DATE: March 8, 1972

SUBJECT: Flap Motor/Right Rudder Cable Clearance Inspection

SERIALS AFFECTED: All Model AA-1 and AA-1A Aircraft

FIGURE 1
FLAP TRUNION MOUNT DETAILS

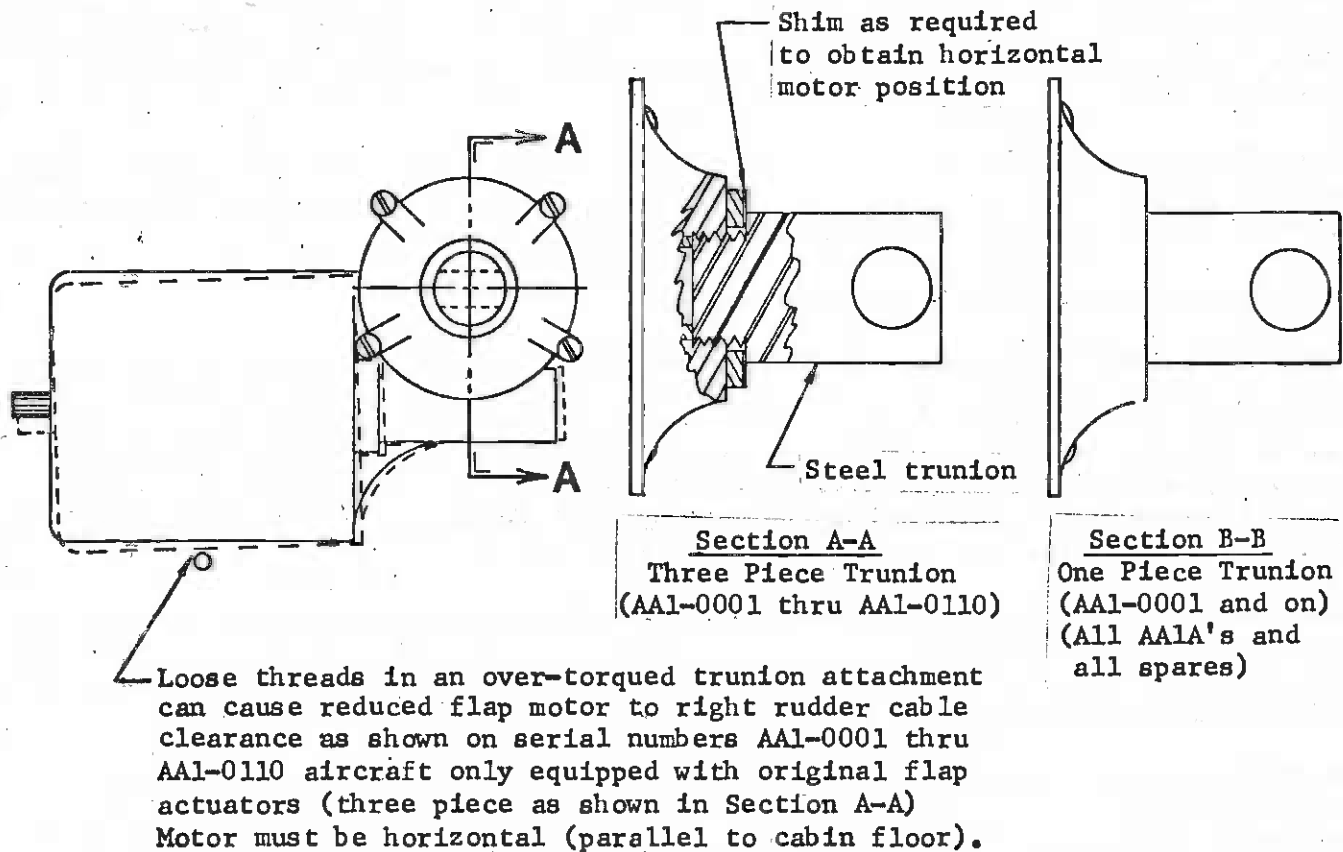
On AA-1 aircraft, serial numbers AAL-0001 through AAL-0110, the actuator end cap is a three (3) piece assembly, utilizing a threaded steel trunion which is screwed into the end cap (see Figure 1). These units should be checked to verify that the steel trunion fitting is secure in the end cap and that it has not been overtightened, causing the motor housing to be rotated down closer to the cables, thereby reducing cable clearance. In the event that it had been overtightened, it can be adjusted by shimming, to position the flap motor parallel to the floor (see Figure 1).

When the correct shimming has been determined, reinstall the trunion using stud lock grade Loctite on the threads to prevent loosening in service. This three (3) piece end cap assembly may be replaced with the newer design one piece end cap, part number G5011-1B mentioned above, any time replacement is necessary.

FIGURE 2
FLAP MOTOR/RUDDER CABLE CLEARANCE
INSPECTION AND BRACKET MODIFICATION
INSTRUCTIONS

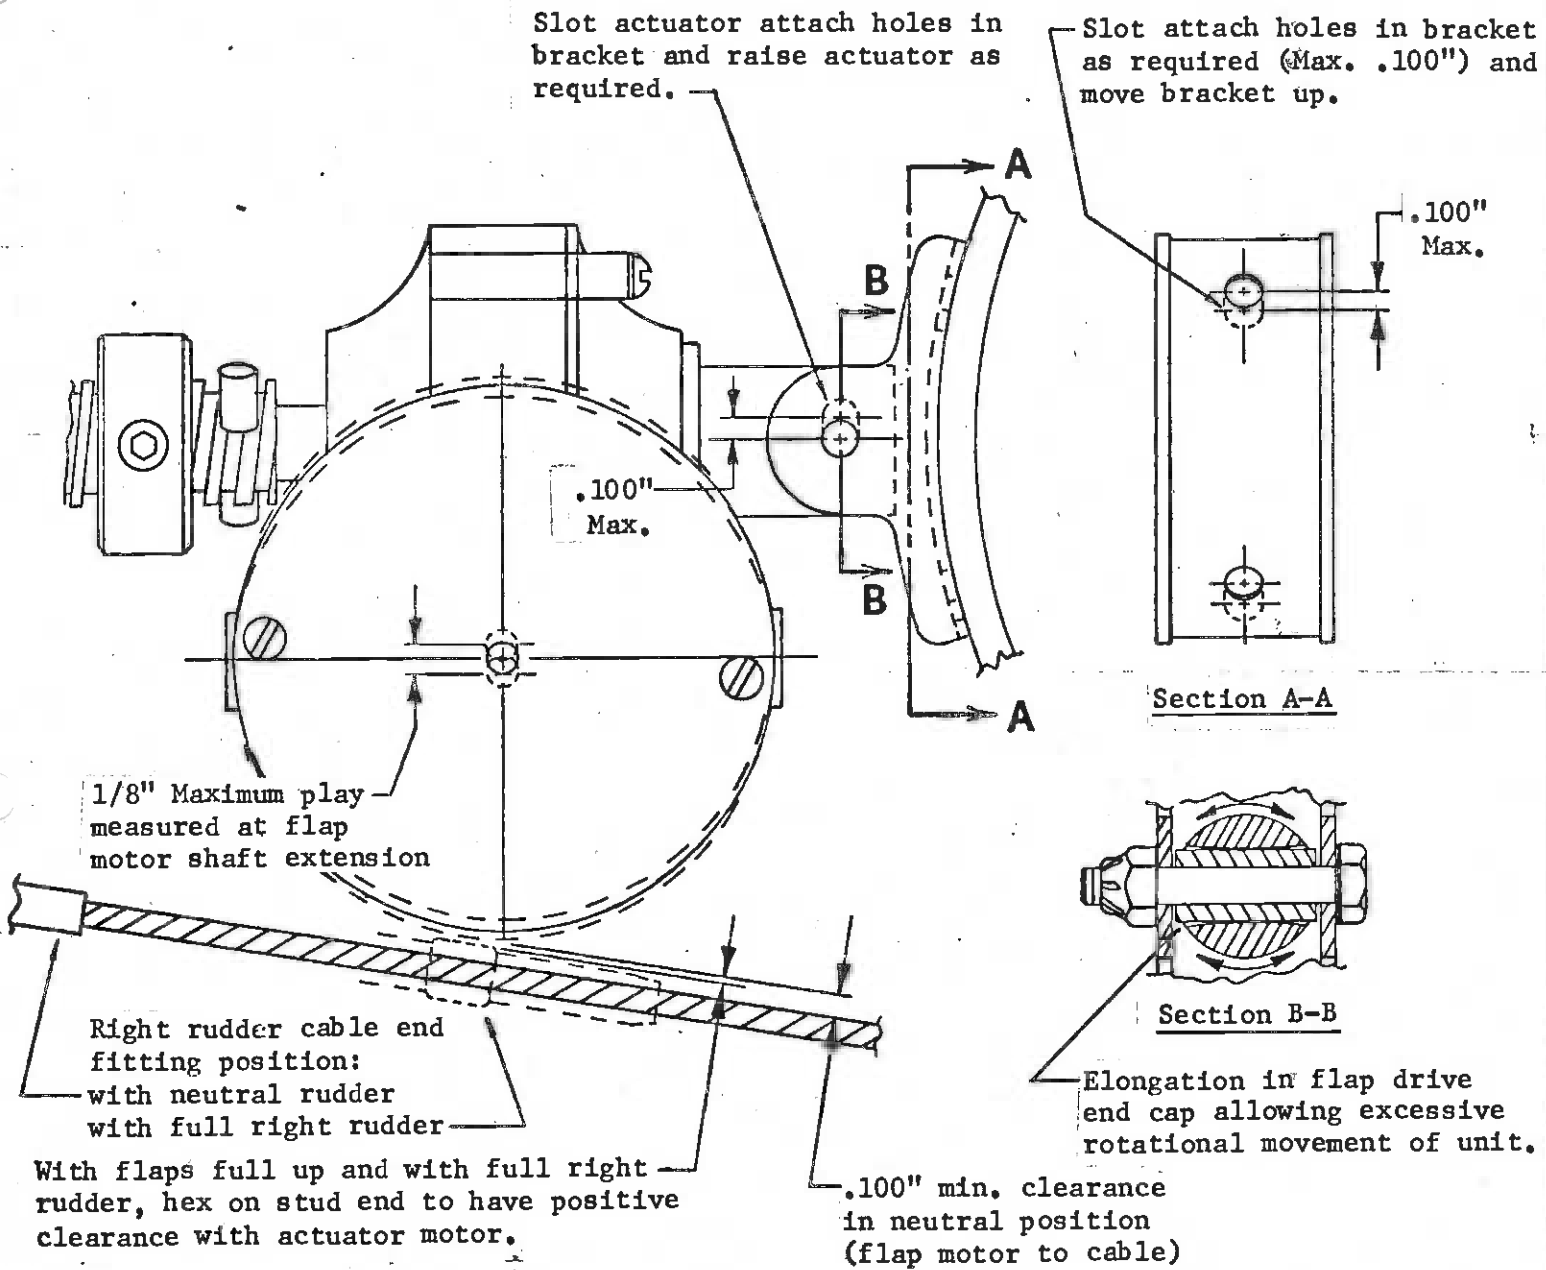
If the movement is less than 1/8" and the cable clearance is less than .100", then the actuator attach bracket holes may be slotted per Figure 2, as required, to raise the actuator up and obtain the required rudder cable clearance.

If, with a correctly installed trunion, the cable clearance is still less than specified above, the actuator attach bracket holes may be slotted per Figure 2, as required, allowing the unit to be raised up, to obtain the correct cable clearance.

Do not raise actuator more than required to obtain desired cable clearance as interference between the motor housing and console/right seat track can occur.

- Step 1 - Slot bracket holes as necessary per Sect. A-A.
- Step 2 - Slot bracket holes (.100" Max.) at trunion mount if more clearance is required than obtained with maximum Section A-A slotting.
